FILE NUMBER: PLN23-075

SUBJECT: Design Review, Grading Approval, and Special Permit

SITE LOCATION: 19471 Mountain Way, Los Gatos, CA 95030 (APN: 510-53-022)

Your application for Design Review and Grading Approval for an addition to the first and second story to an existing one-story Single-Family Residence, and a Special permit for a new detached garage located within the front and side setback, received on the above date is deemed **incomplete**. For the application processing to resume, you must resolve the following issues and submit the information listed below.

Fig. 4.20-1
Accessory Building Height

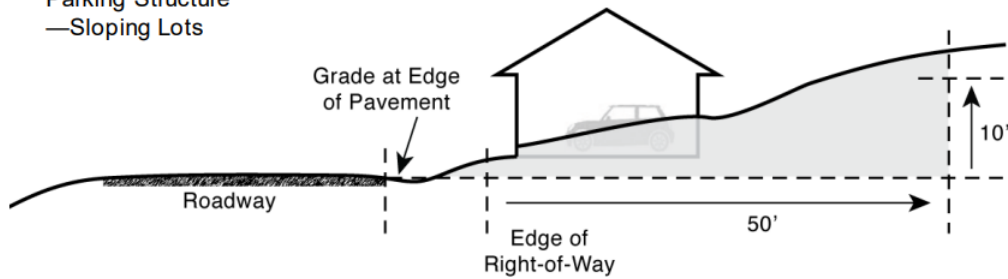
9. On sheet A2.3, please label the final exterior grade, and provide the height for the proposed detached garage using roof-averaging height measurement. Pursuant to County Zoning Ordinance, the height shall be measured from the final exterior grade to the average vertical dimension between the ridge and top plate of the wall (see Fig 4.20-1).

Note: Pursuant to County Zoning Ordinance 4.20.020(E)(3), “*Accessory buildings or structures exceeding 12 feet in height (16 total feet with gable/hip roof allowance as provided in subsection 4.20.020(E)(1)(a)) on lots 2.50 acres or larger **are subject to side and rear yard setbacks of no less than 30 feet**”.*
